Dewberry Response to USGS Review of the Eastern Shore Virginia QL2 LiDAR BAA Project

Produced for U.S. Geological Survey

USGS Contract: G10PC00013

Task Order:G15PD00284

Figure 2- DEM_S23_2767_20. The above image is an overview of the DEM where USGS made a call to hydro-flatten a lake greater than 2 acres in size. The bottom image shows an overview of the DEM after Dewberry hydro-flattened the lake.

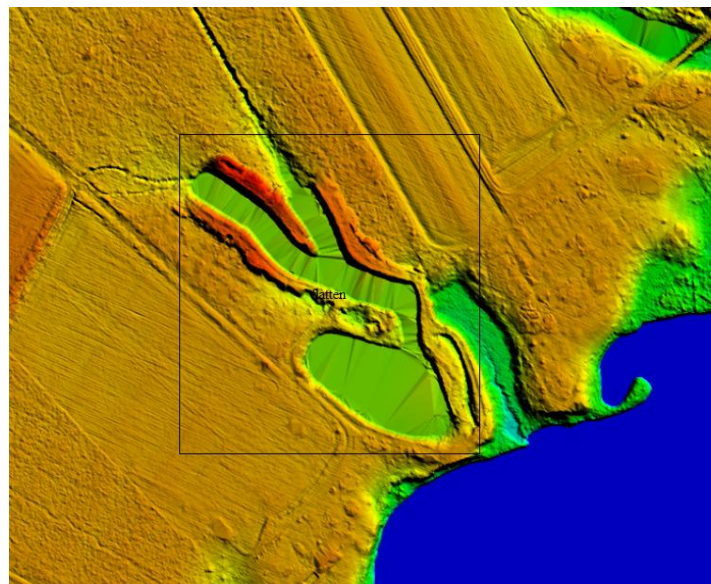
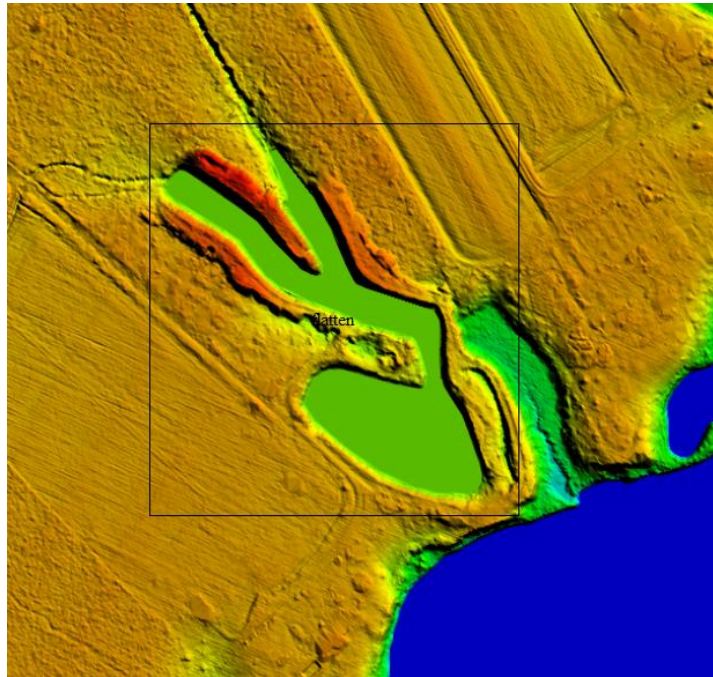
USGS made twenty four hydro-flatten calls. Fifteen of those calls were of lakes greater than two acres that need to be flattened. Dewberry agrees with these instances and they have been corrected. An example is shown below.

Figure 3- DEM_S23_2662_40. The above images is an overview of the DEM where USGS made a call to hydro-flatten a tidal area to an elevation of -3.3. This elevation change caused floating in two areas.

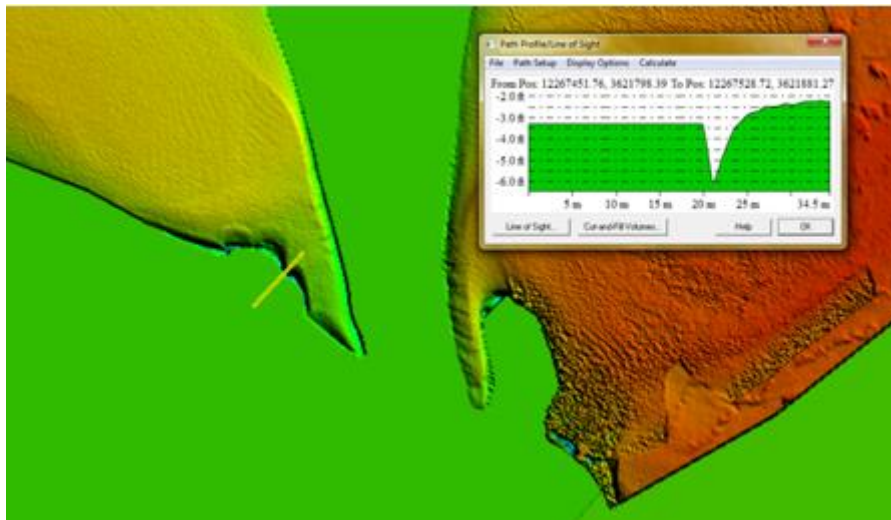
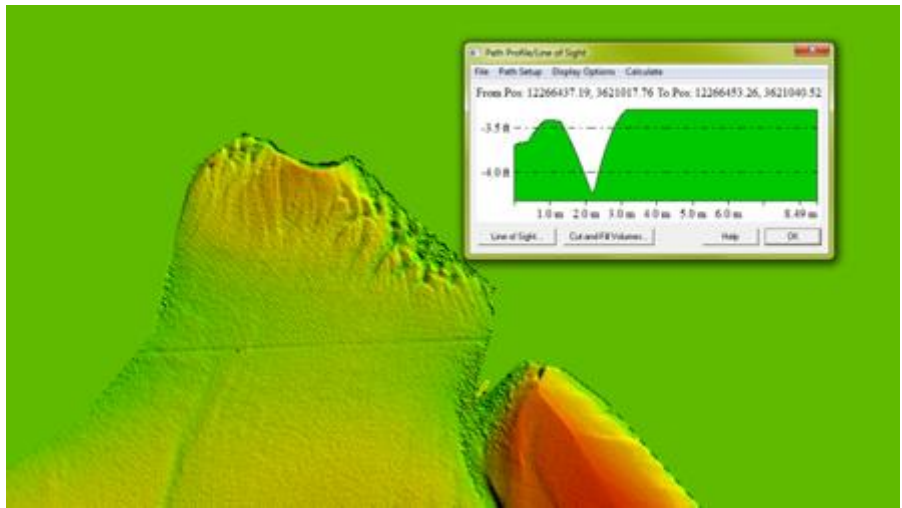
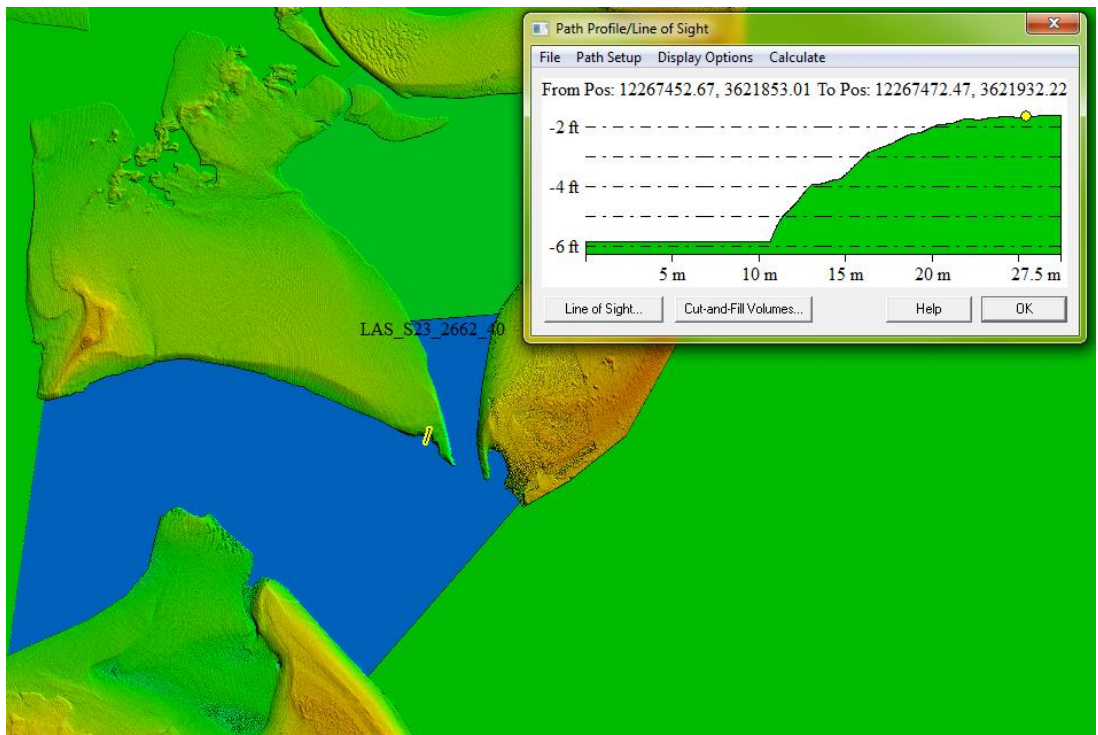
USGS made nine additional hydro-flatten calls with requested elevations. Dewberry adjusted the elevation to USGS' request which caused areas of the waterbody to be floating. Dewberry decided to keep the original stair stepped elevations in the tidal. The USGS Lidar Base Specification v1.2 allows for vertical discontinuities within the tidal waterbodies that can be retained in the DEM.

Figure 4- DEM_S23_2662_40. The above image is an overview of Dewberry's DEM set with the original elevations.

Figure 7- DEM_S23_2886_10. The top image is an overview of the DEM where USGS made a call to fix a floating waterbody. The bottom image is an overview of the DEM with the adjusted breakline elevation.

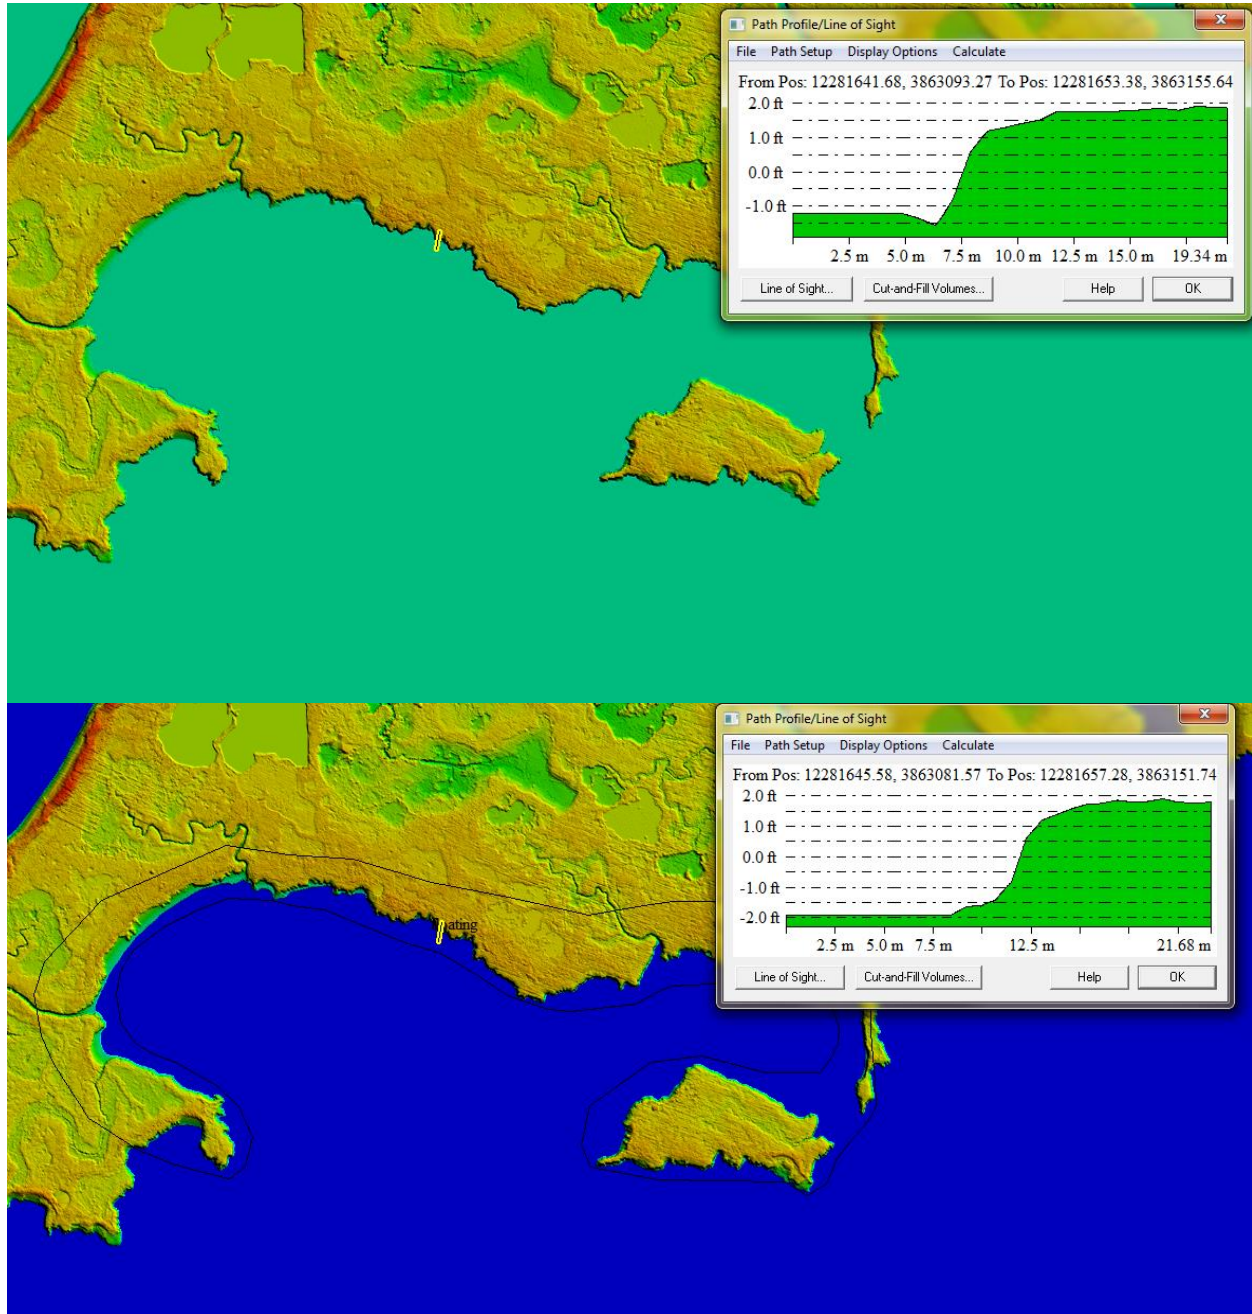
USGS identified twenty two areas that needed breakline adjustments due to floating areas of water. Dewberry agrees with these instances and they have been corrected. Below is an example.

Figure 8- DEM_S23_2783_30. The above image is an overview of the DEM where USGS made a data void call. The below image is an overview of the reprocessed DEM with the data void removed.

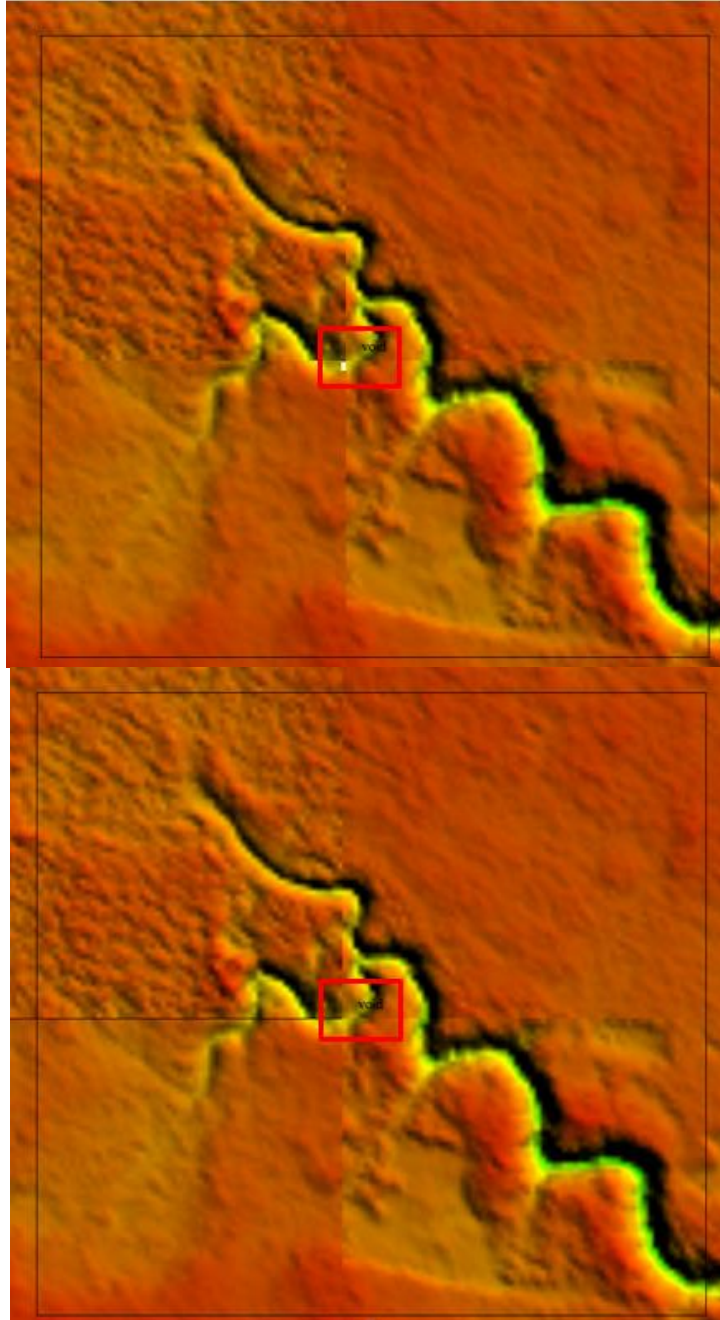
USGS made fifty eight data void calls. Dewberry confirmed that the voids were created during processing and have recreated the DEM tiles that contained voids.

Figure 10- DEM_S23_3865_10. The above image is an overview of the DEM where USGS made a building removal call. The below image is an overview of the reprocessed DEM with the building completely removed.

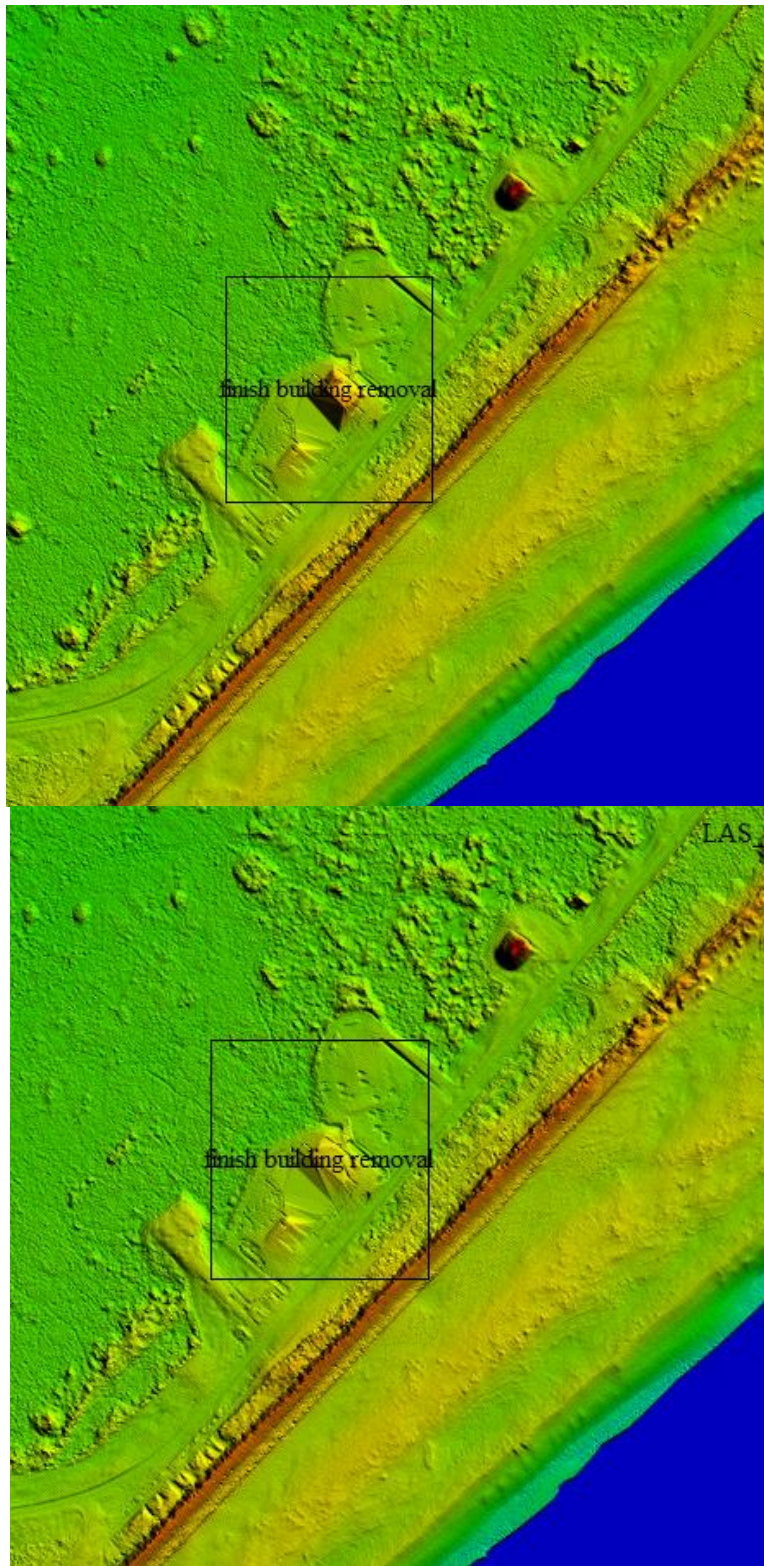
USGS made eleven DEM calls. Dewberry has corrected all the locations. Examples are provided below.

Figure 11- DEM_S23_3729_30. The above image is an overview of the DEM where USGS made a temporal call.

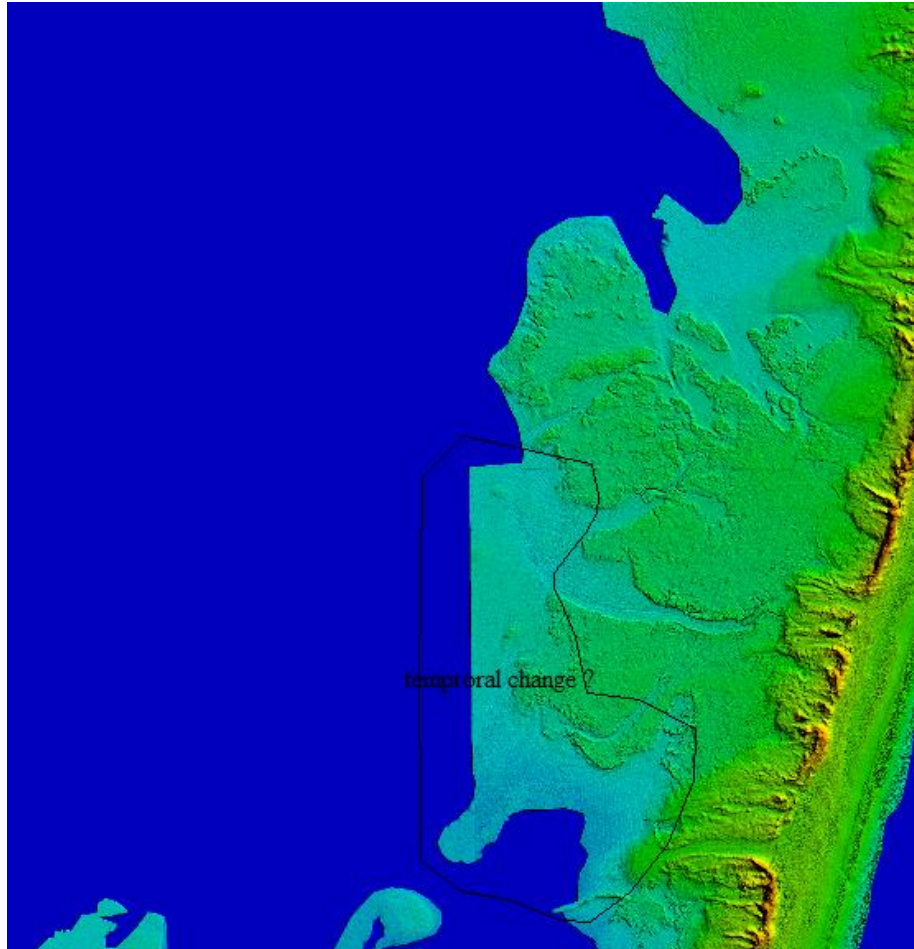
USGS made one call to confirm a location was temporal. Dewberry reviewed the call and determined that the area is temporal and cannot be adjusted. Dewberry added this area to the Temporal Calls shapefile located in the Other Ancillary Data folder.
